Docket Item # 8
BAR CASE # 2008-0053

BAR Meeting
June 18, 2008

ISSUE: Alterations
APPLICANT: Rosemary Furfaro and James Woods
LOCATION: 511 Queen Street
ZONE: RM/Residential

Figure 3. Existing conditions.

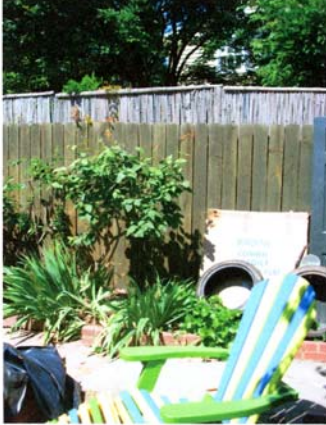
The existing wood fence is in a deteriorated condition and nearly covered in vegetation. The existing fence sits atop railroad ties on the east elevation along a utility easement. Due to the heavy overgrowth, the railroad ties are not easily visible at this time. The height of the existing wood fence and railroad ties ranges from 8' to 8.5'. The board and lattice fence is proposed to be 7' in height and constructed on top of the existing railroad ties. As a result, the height will range from 7.5' to 8' on the east elevation. Staff has strong concerns regarding the construction of what will mostly be an 8' fence.

The applicant has explained that the grade of the rear yard is approximately 1½ -2' higher than the surrounding grade at the alley. While, staff understands the desire to have a fence at least six feet in height in the interior of the yard, the BAR's purview is what is visible from the public

Figure 4. Proposed site plan, fence and trellis.

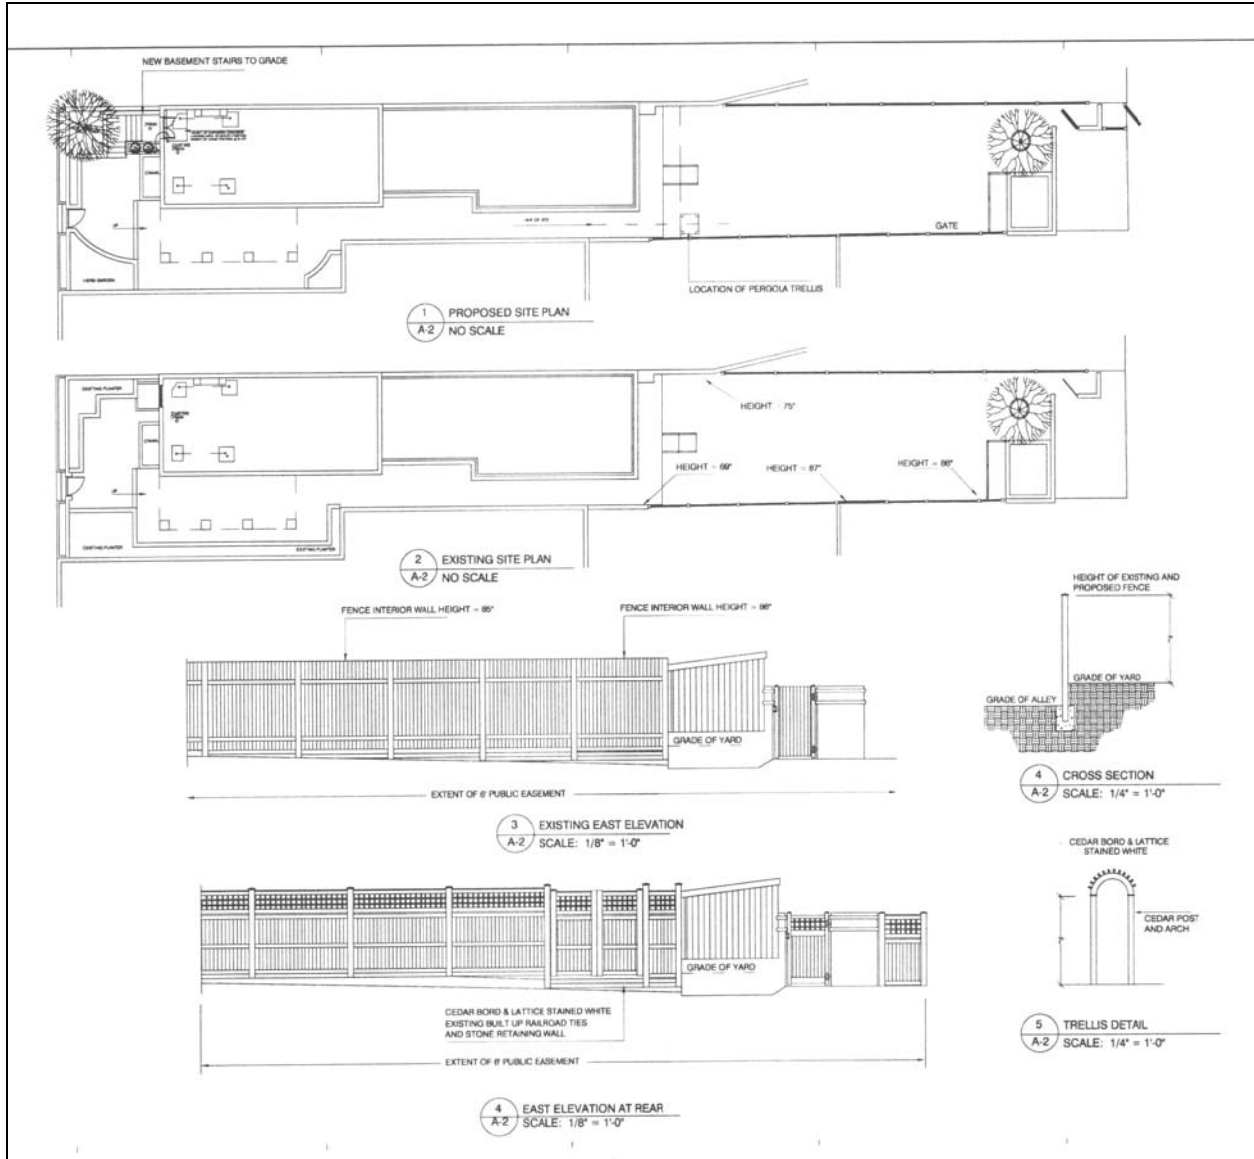
right-of-way. Staff does not find a compelling reason for approving what will amount to an eight foot fence. There is no architectural or historic reasoning to approve such a height. However, recognizing the grade difference, staff considers that a board fence with open lattice top, reduced to six feet overall but still allowed to be installed on the existing railroad ties, would be the most acceptable option.

The proposed trellis located at the rear of the upper patio features an arch with decorative knobs. The proposed height (as measured from the drawings submitted) will be approximately 9' in height and 11' above the alley grade. Again, staff is concerned regarding this height. Staff recommends the trellis height be reduced by at least one foot.

1. That the proposed fence shall not exceed 6 feet in height (but may be installed upon the existing railroad ties) and that the applicant shall provide specifications to staff of the proposed fence for approval prior to its installation;
2. That the proposed trellis be reduced in height by at least one foot from approximately 9 feet to 8 feet; and,
3. That the applicant shall provide staff with an alternate lantern that is more historically appropriate for final approval.

Figure 5. Existing and proposed elevations.

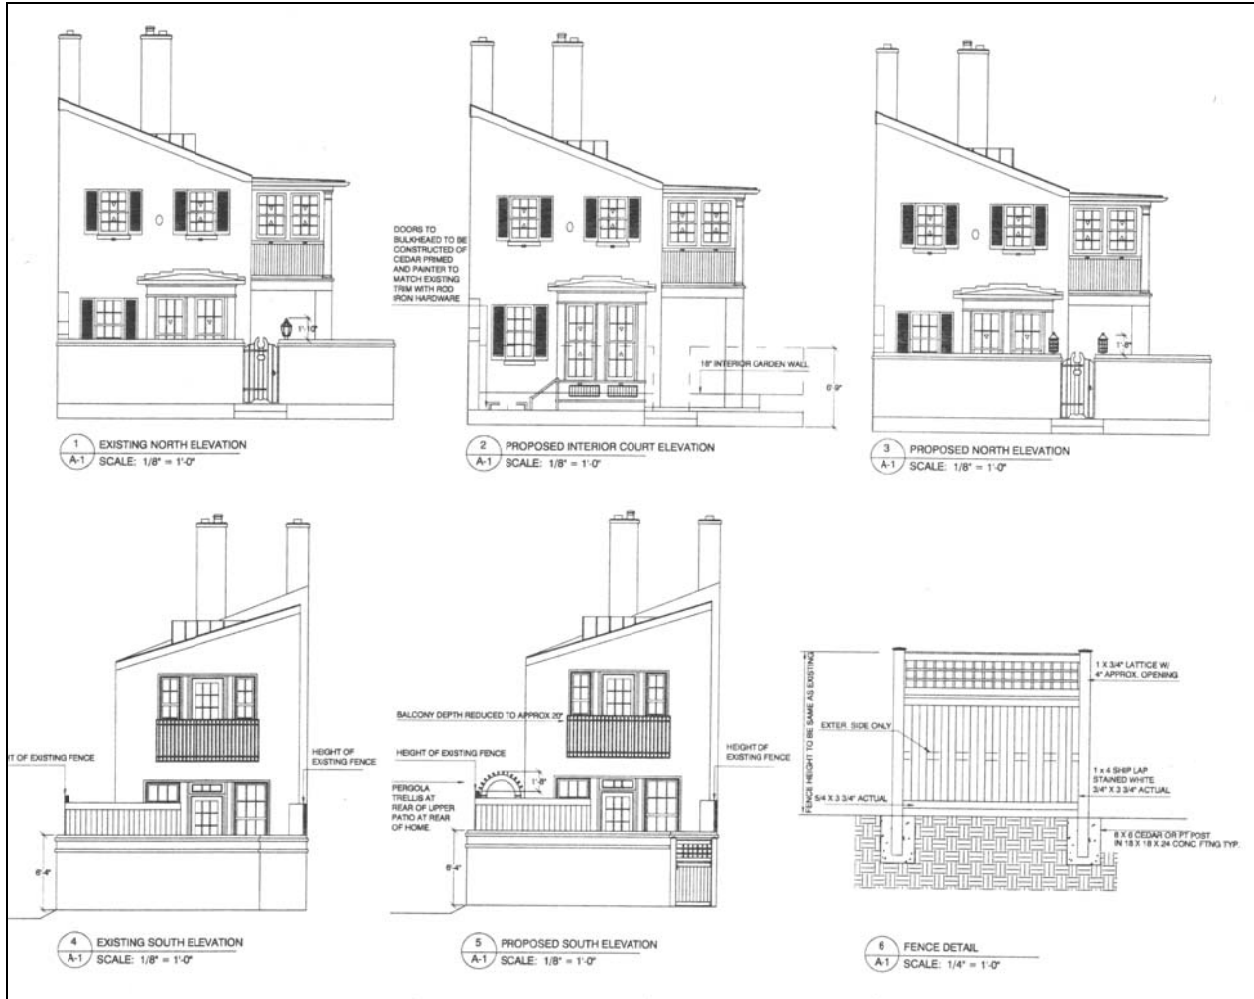
Staff has no objection to the reduction of the balcony depth from 4' to 20".

Figure 6. Details of proposed lantern and lattice fence.

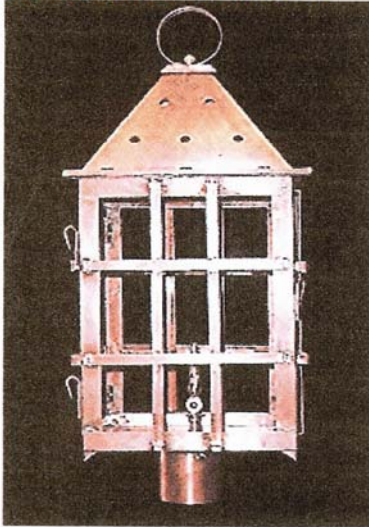
The applicant should bring a cut sheet of the proposed fence design to staff for approval prior to installation. Staff supports the proposed fence design reduced to six feet.

Staff has concerns regarding the design of the lantern that is out of character with other lighting fixtures in the district. The lighting appears to be too heavy in form and medieval or Tudor in character, making it inappropriate for this 18th-century dwelling. In addition, the proposed height and size of the lanterns will be prominent on the front brick wall, making it advisable to have a more appropriate design. One alternative would be to remove the grills on the faces of the lantern. Staff requests that the applicant propose a more historically appropriate lantern for staff approval.
